**COUNTY OF SAN MATEO**  
**PLANNING AND BUILDING**

**SUBJECT: Coastside Design Review Continuation**  
208 Magellan Avenue, Miramar  
APN 048-031-200; County File No. PLN 2018-00490

NEW MITHAL RESIDENCE  
MAGELLAN AVENUE  
HALF MOON BAY, CA

**PLANTING PLAN**

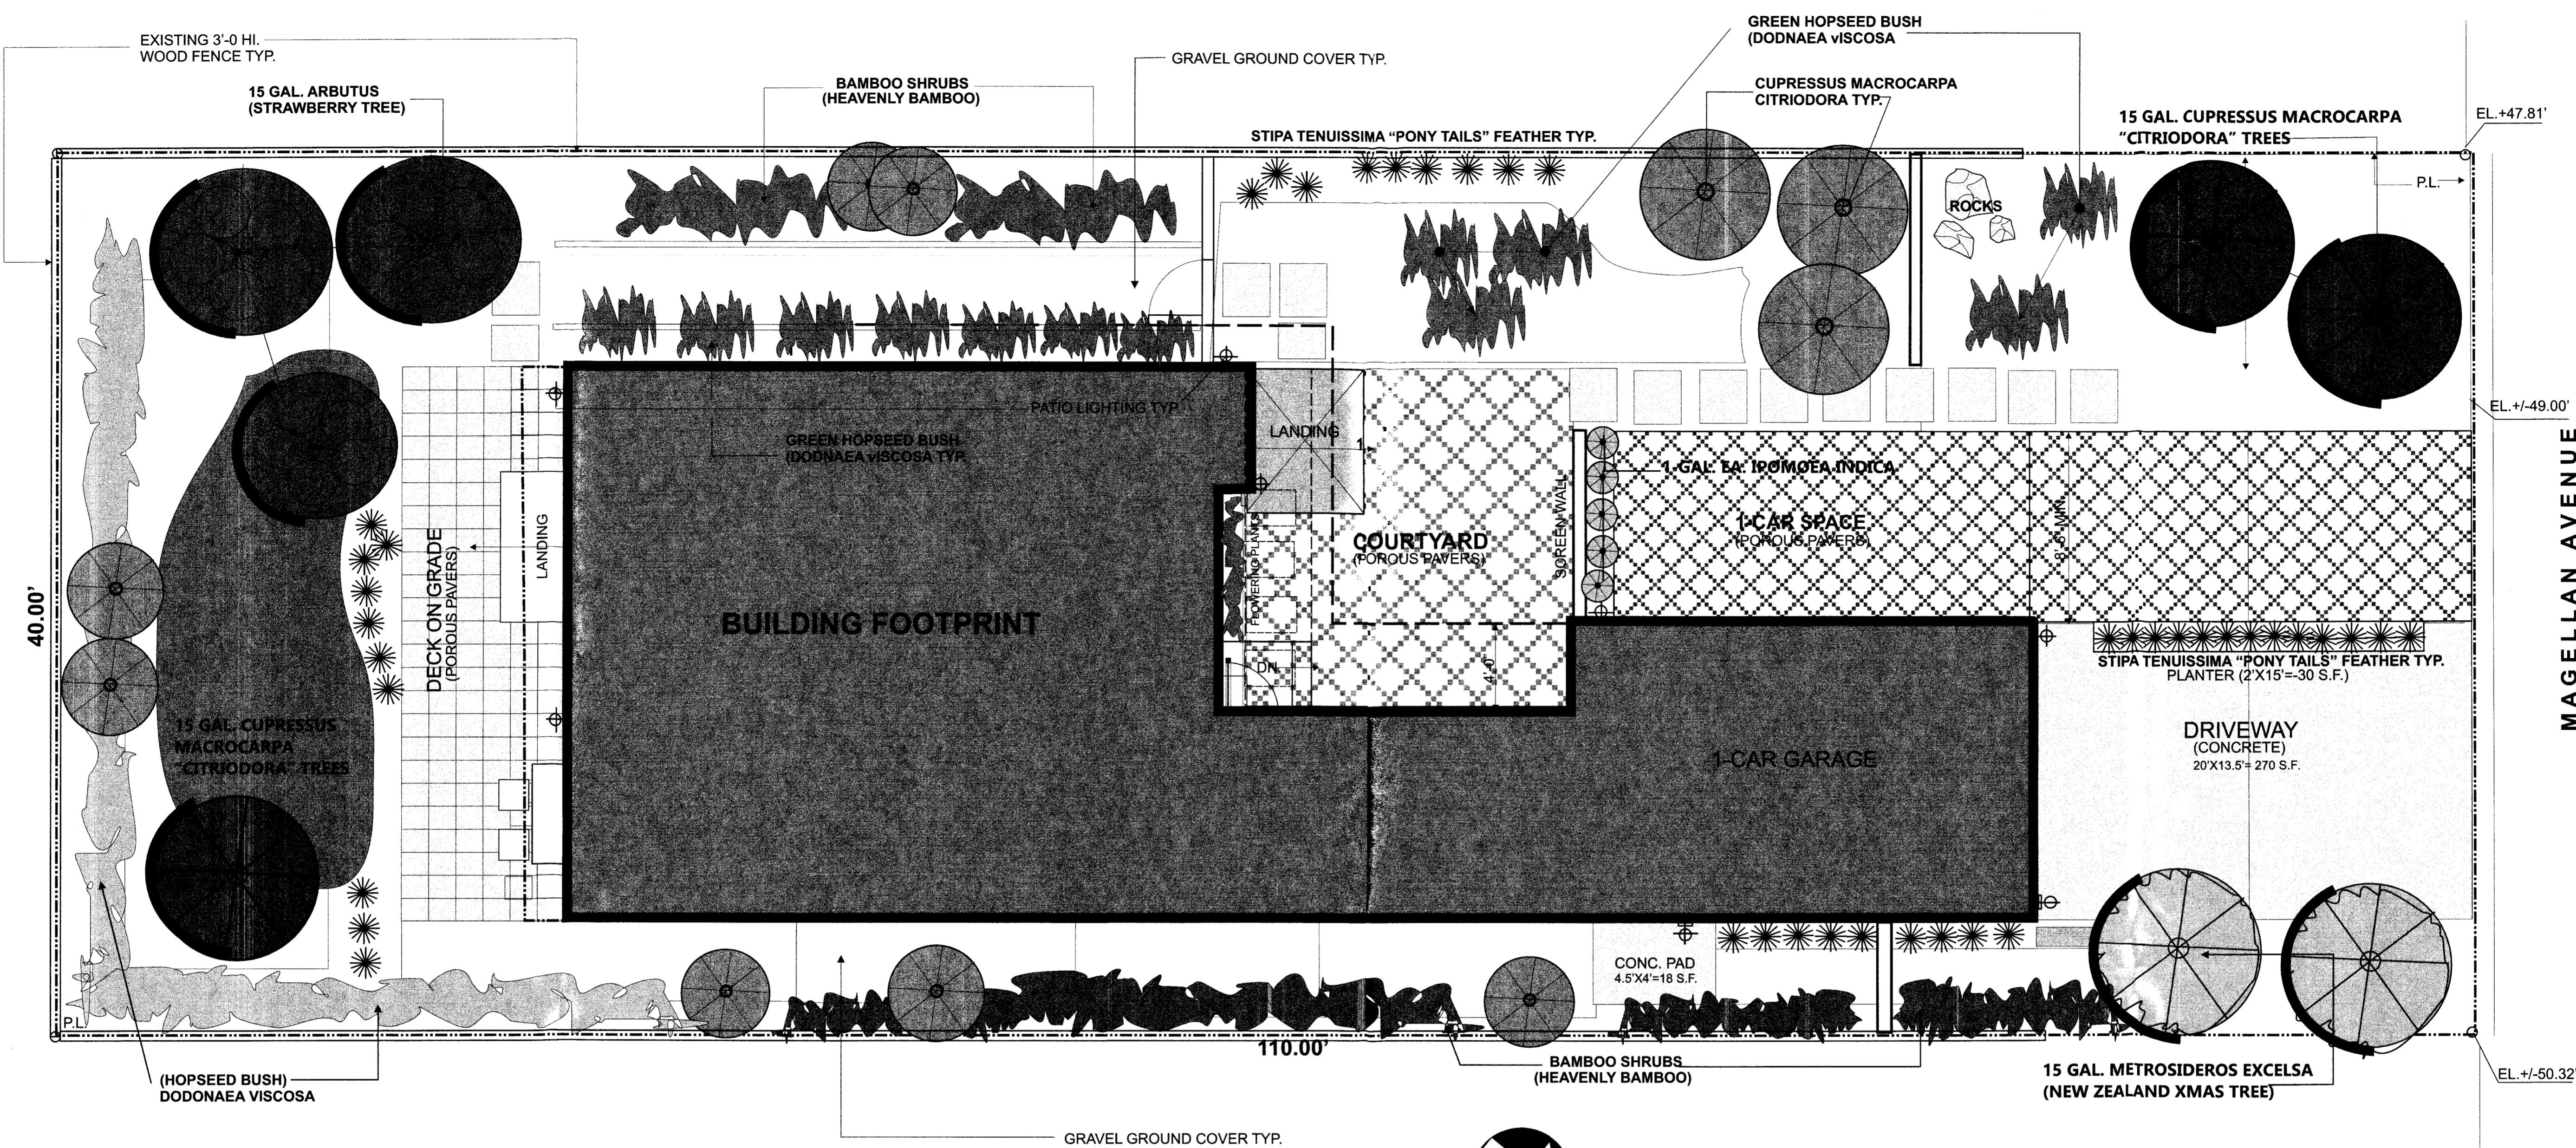
13. Provide perimeter shrubs along rear and side boundaries, such that tall-growing shrubs are used in alternating groups of three to five. This will create a more natural planting scheme and reduce the visual hedge-effect and visually soften the house. Consider using Dodonaea (Hopseed Bush).

14. Add another tree in the southeast (rear yard) corner of the lot.
15. Call out all shrubs and trees. Do not use Mayten trees. Select another tree such as Cupressus Macrocarpa "Citriodora".

16. Reduce proposed lawn area, and use more groundcover plantings. Provide lawn area calculation (lawn areas cannot exceed 25% of landscape area per the prescriptive approach for the Water Efficient Landscape Ordinance (WELO)).
